SUBDIVISION REVIEW SHEET

CASE NO.: C8-2022-0146

SUBDIVISION NAME: Parkside Section 2 At Wildhorse Ranch

CITY OF AUSTIN –DEVELOPMENT SERVICES DEPARTMENT
SUBDIVISION APPLICATION – MASTER COMMENT REPORT

PRELIMINARY PLAN (1-OF-3)

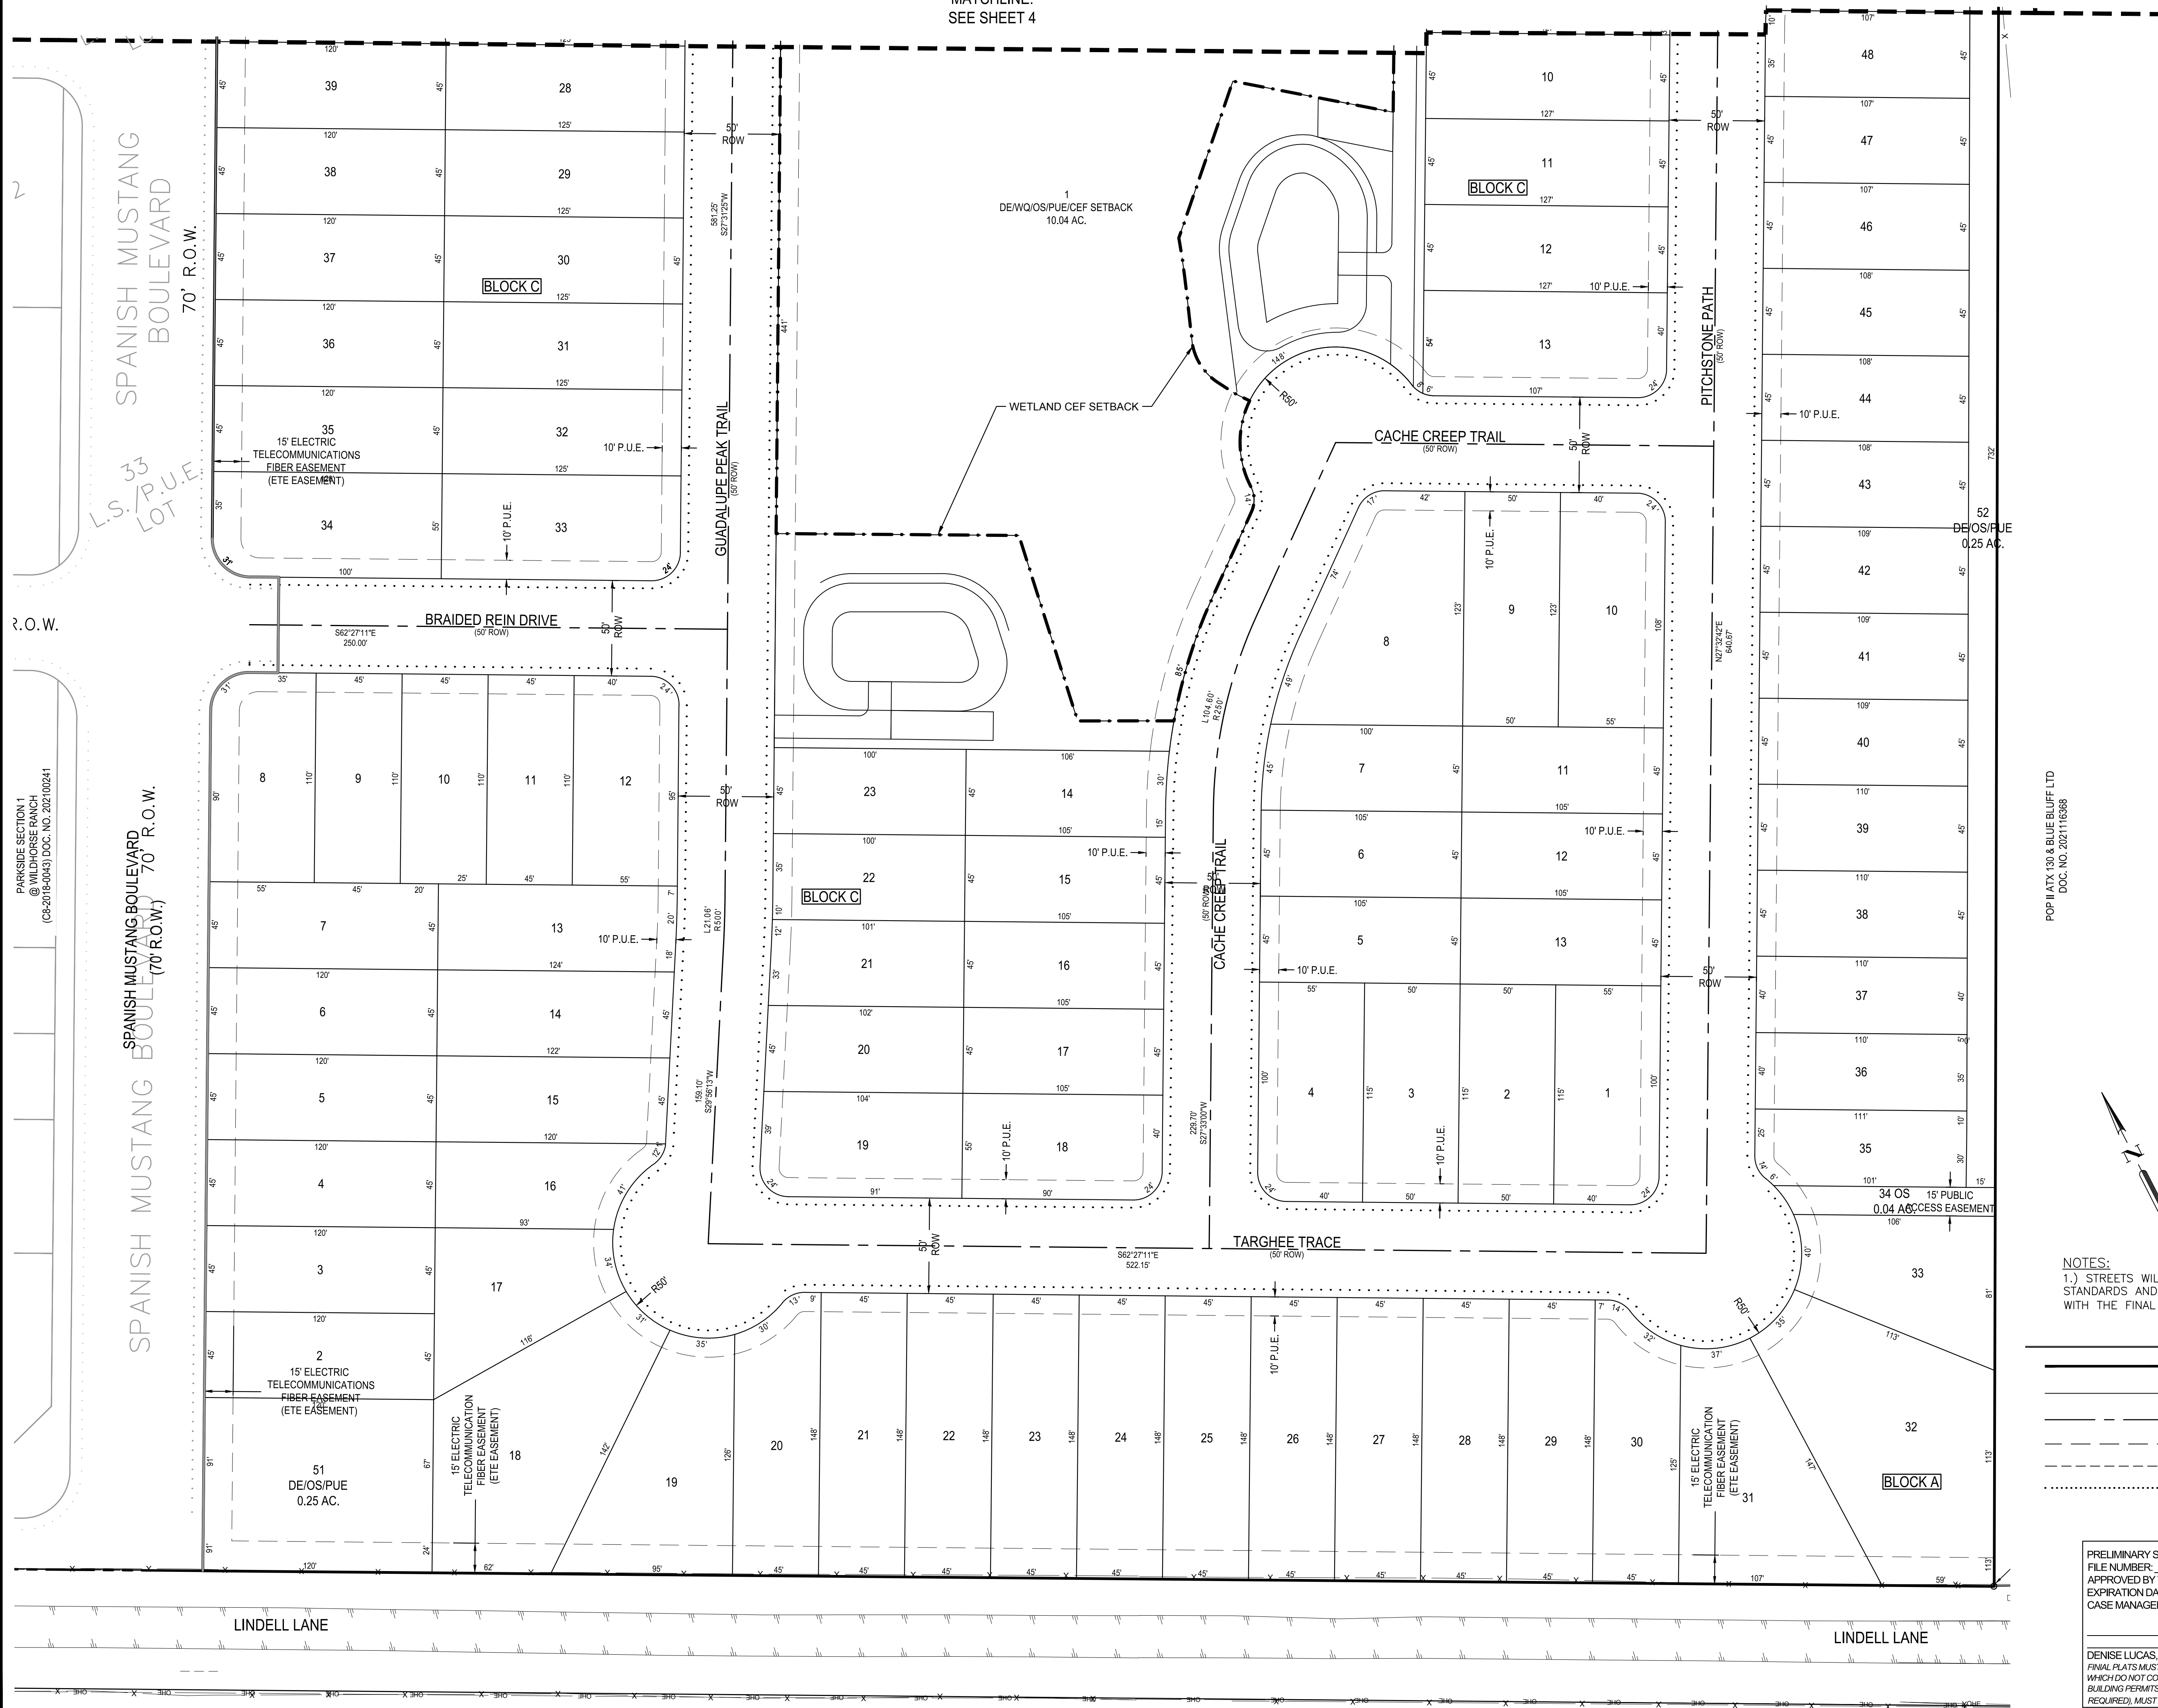
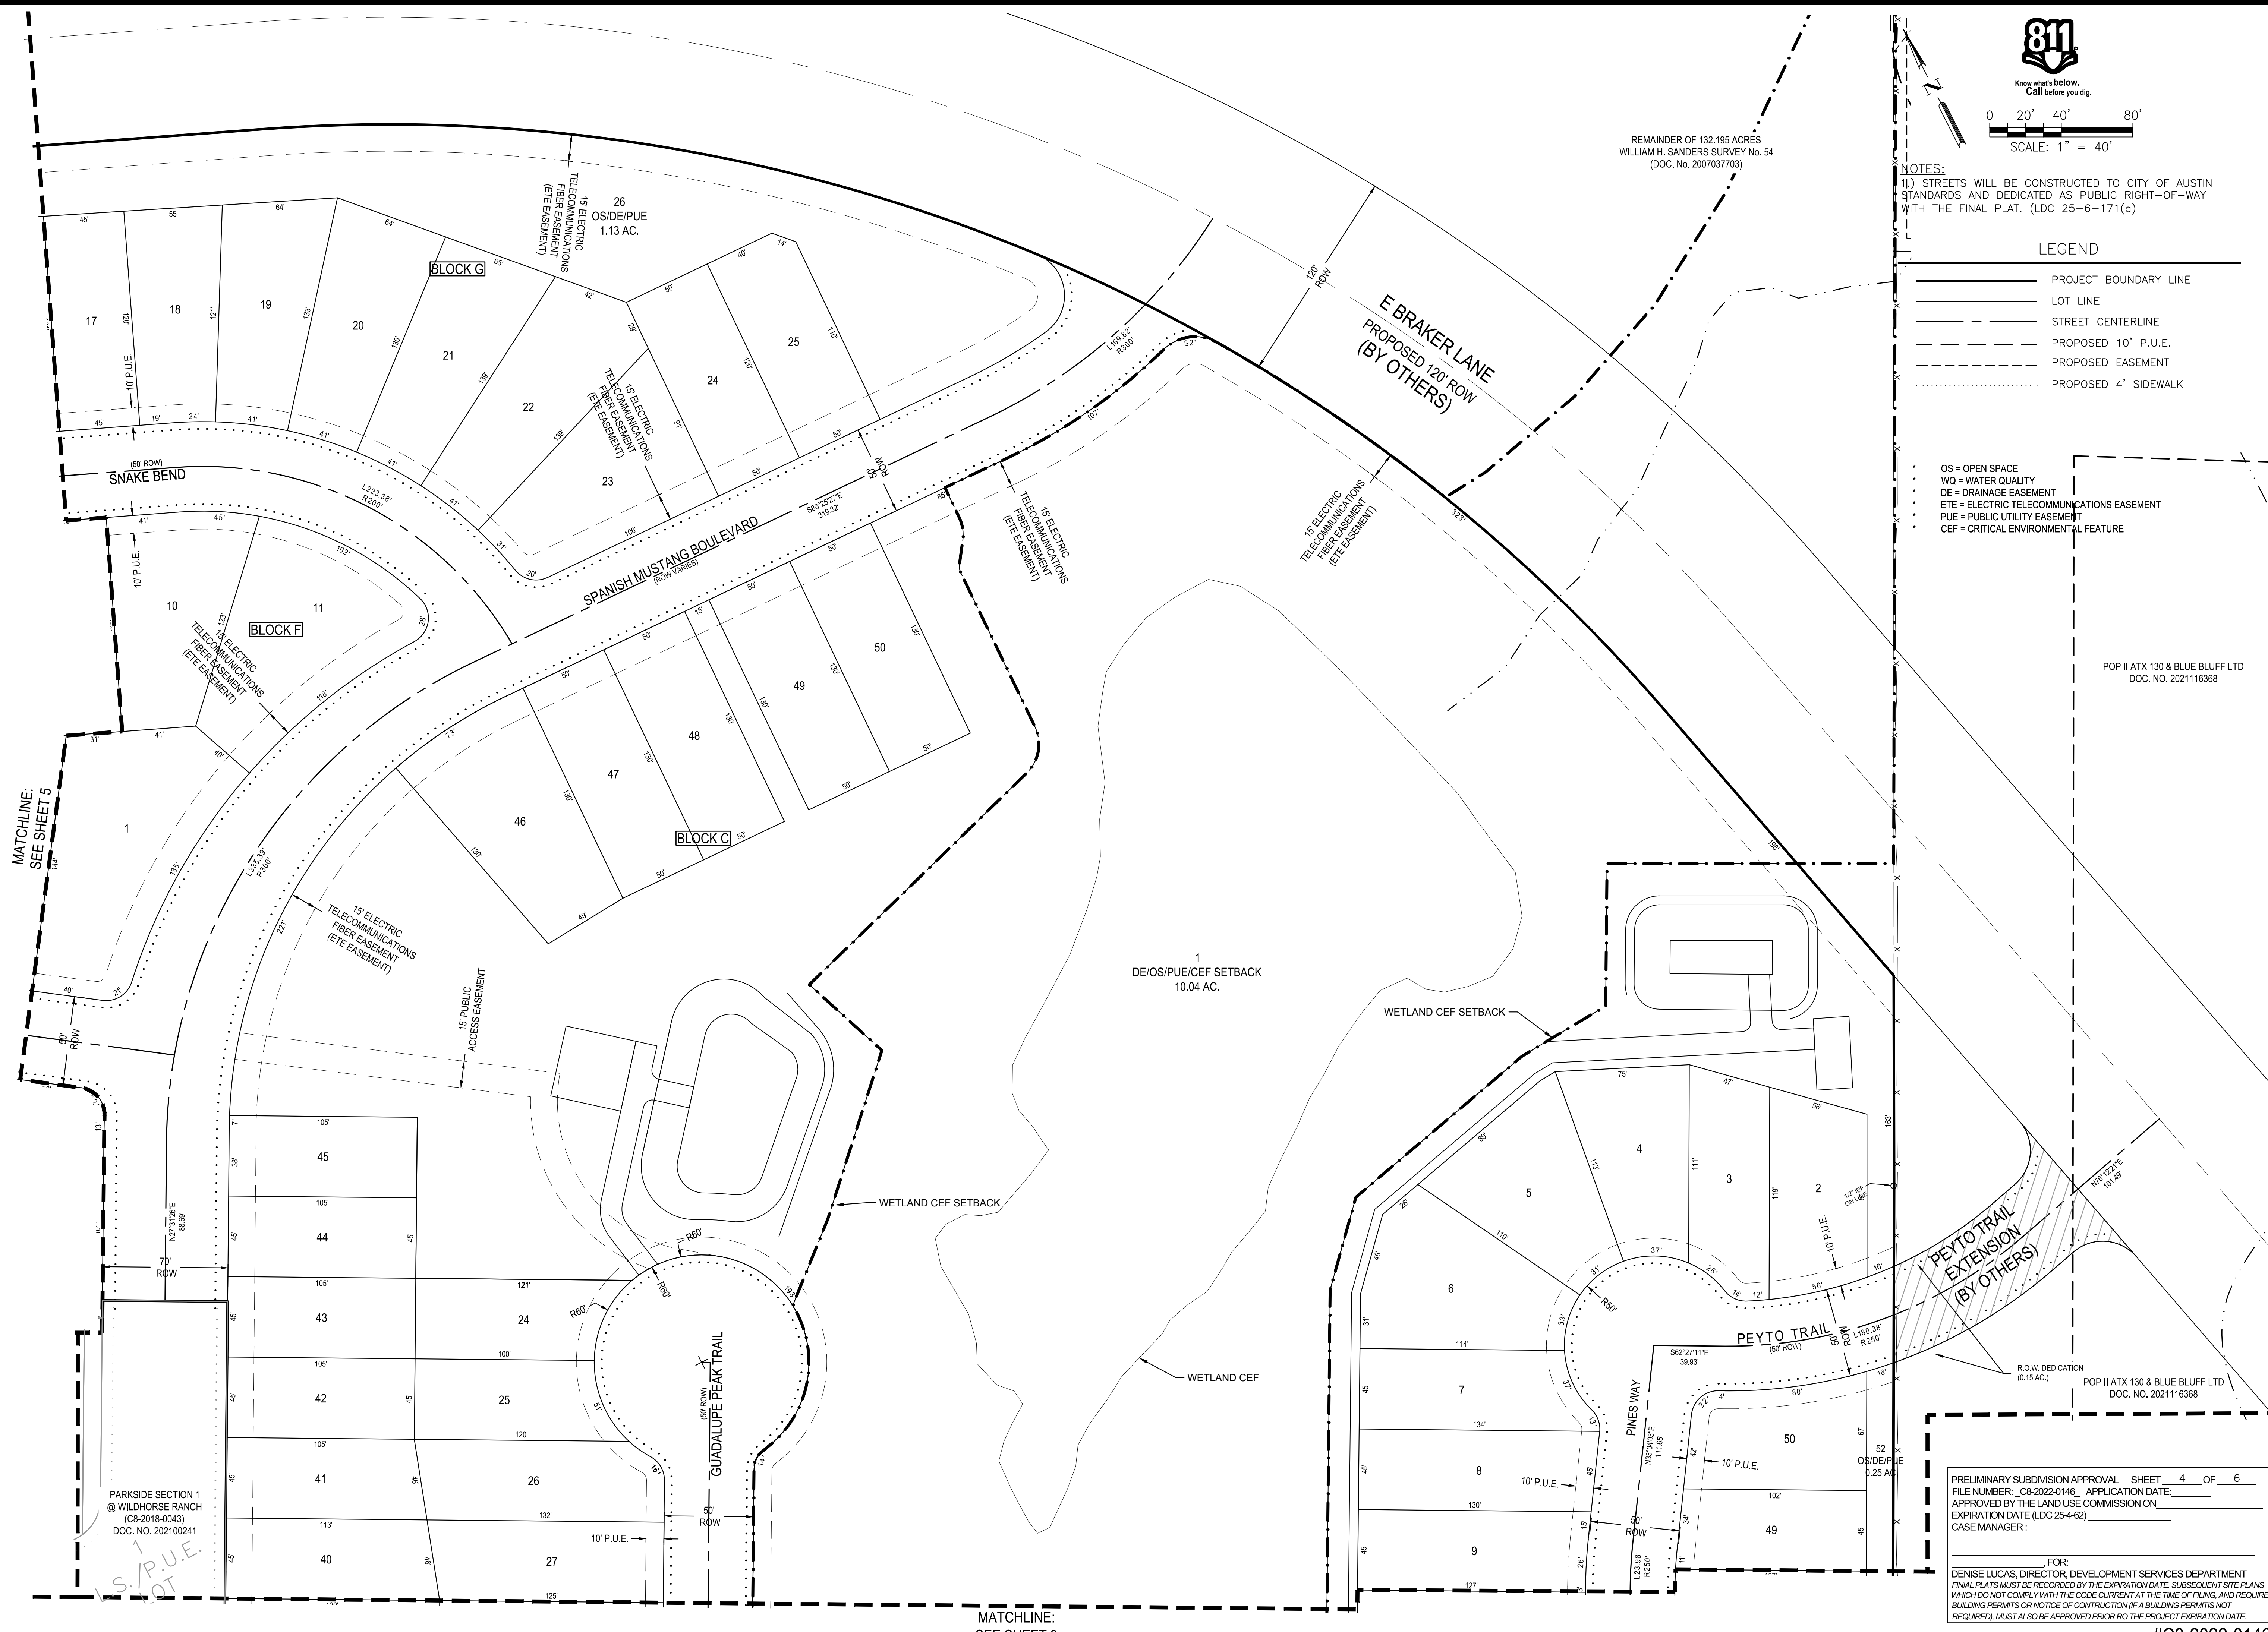
ATD 1. Round the intersection of Lindell Lane and Spanish Mustang Blvd. to provide at least a 15 ft. right-of-way radius, as ROW dedication. TCM, 3.6.2.A./1.3.1.D.3 (Lot 51 Block A).

ATD 2. Sidewalks are required on the subdivision side of Lindell Lane. Identify the location of the sidewalks by a dotted line on the preliminary plan and include the sidewalk symbol within the legend and the sidewalk note (#15). LDC 25-6-351. TCM, 4.1.1.
